Docket Item #7
BAR CASE #2005-0284

BAR Meeting
December 21, 2005

ISSUE: Demolition and encapsulation

LOCATION: 211 Franklin Street

Figure 4 Front elevation of side addition to be demolished

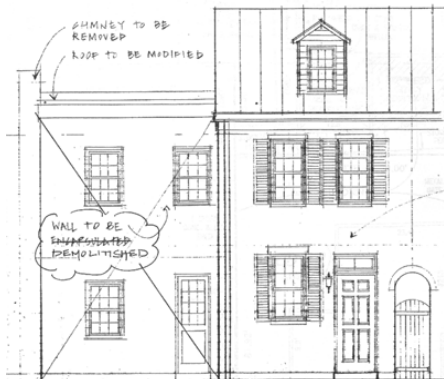
Staff believes that none of the above criteria are met as applied to the two story frame addition on the west side of the brick house. The side addition to the original house is a fairly ungainly mass of little distinction which simply abuts the original rear ell of the brick house. Historic map evidence suggests that the turn-of-the-20th century structure existed as a separate dwelling through the 1940s. It may not have been integrated into the house 211 Franklin Street until circa 1951. A building permit from 1951 indicates that numerous alterations to the addition were completed, including reconstruction of the north (rear) wall, reconstruction of the chimney and raising the overall height of the addition to increase ceiling heights on the second story (permit

For these reasons, Staff has no objection to the proposed demolition of the frame wing on the west side of the house at 211 Franklin Street. In addition, Staff notes that the extent of demolition/capsulation previously approved by the Board for this portion of the house was substantial and that the currently proposed demolition represents a relatively modest expansion of that which was previously approved.
